TI_2618: New I/O module

iCombi Pro / iCombi Classic / iHexagon

29/10/2026

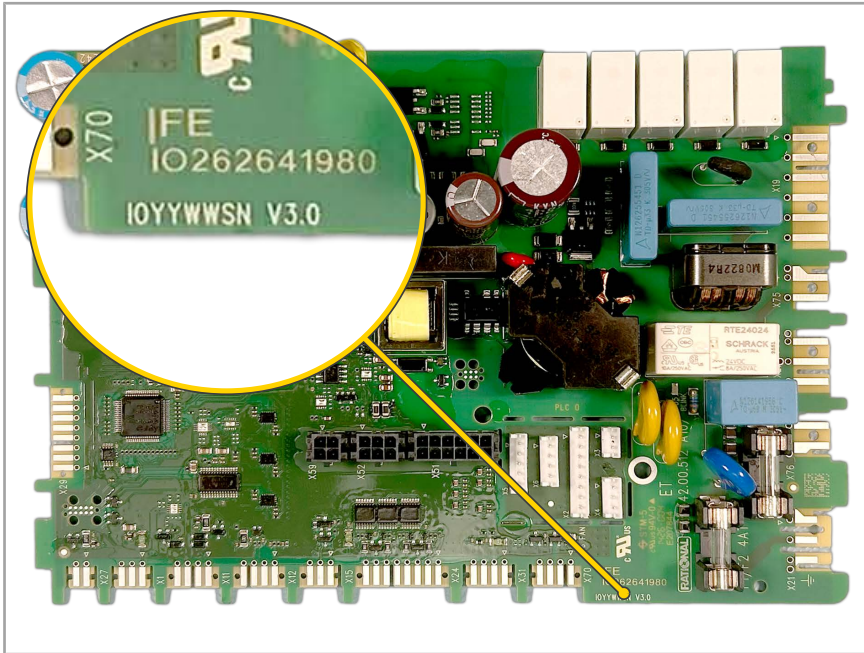
The design of the I/O module has been revised due to new components. The new I/O module A10 with the article numbers 40.08.516P and 42.00.512P (XS) replaces the previous I/O module with the article numbers 40.05.919P and 42.00.280P (XS). The new I/O module is fully backward compatible.

Switched power supply for cooling fan, LED D6 FAN

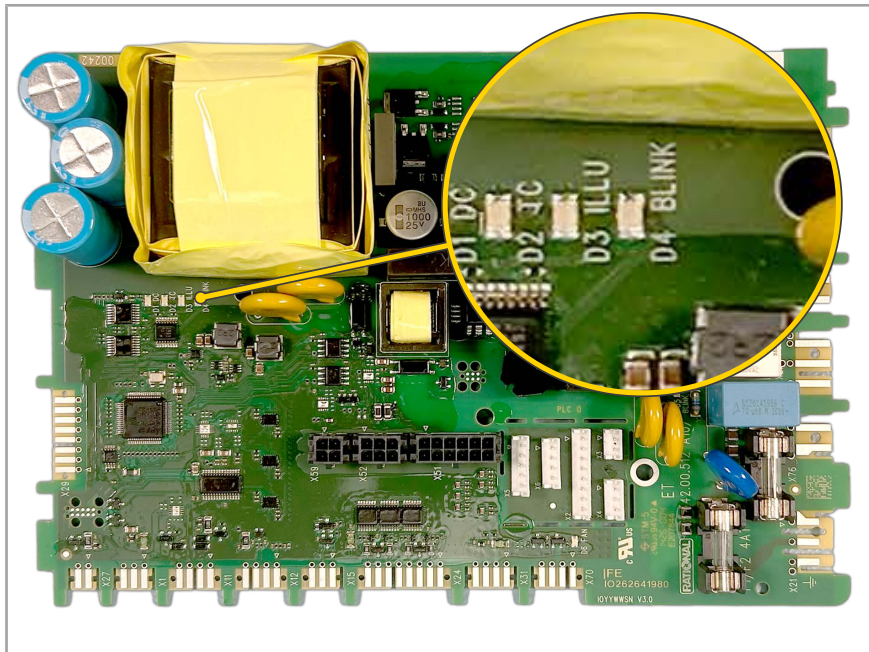
The new I/O module switches the voltage output X70 to +12 V for the cooling fan. The green LED D6 FAN in the immediate vicinity of X70 signals the release of the power supply. If the LED D6 FAN is lit, there is 12 V on the cooling fan. If LED D6 FAN is off, the cooling fan is not receiving power.

Extended diagnostic function of the yellow LED D4 BLINK

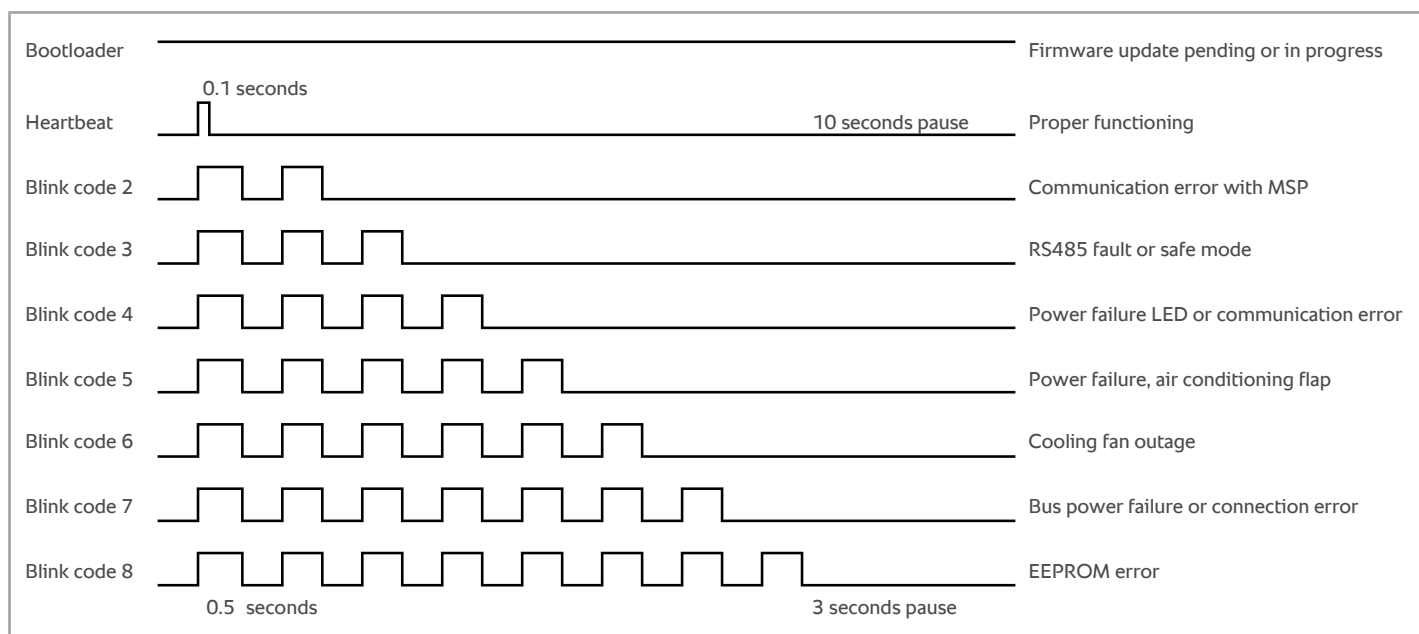
A short flash every 10 seconds (heartbeat) indicates correct operation. Steady light (bootloader) indicates an expected or ongoing firmware update.

Flash codes 2-8 represent the following faults:

Each blinking code is followed by a pause of 3 seconds. The next blinking code then begins or the previous blinking code is repeated.

Improved visibility of the red LED D5 BLINK

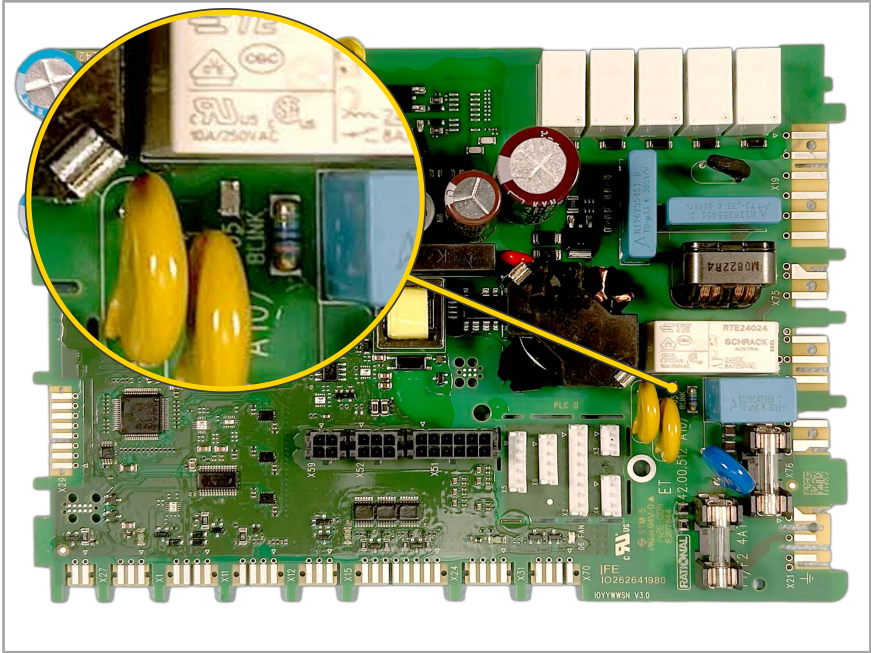
The red LED D5 BLINK is now on the top of the PCB. This makes the LED more visible. Steady light (bootloader) indicates an expected or ongoing firmware update.

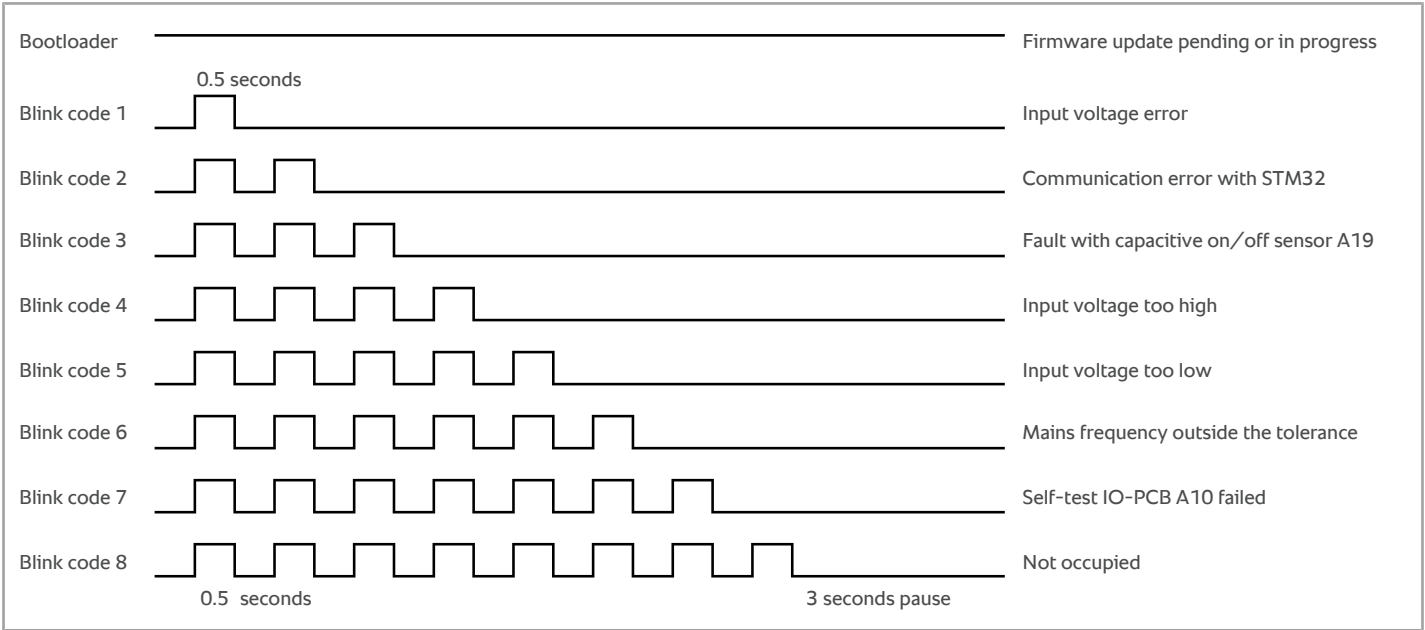
The flash codes 1-8 correspond to the familiar diagnostic concept of the old I/O module:

Each blinking code is followed by a pause of 3 seconds. The next blinking code then begins or the previous blinking code is repeated.

When the unit is switched off, the flash codes 2 and 7 of the red LED D5 BLINK are no longer displayed.
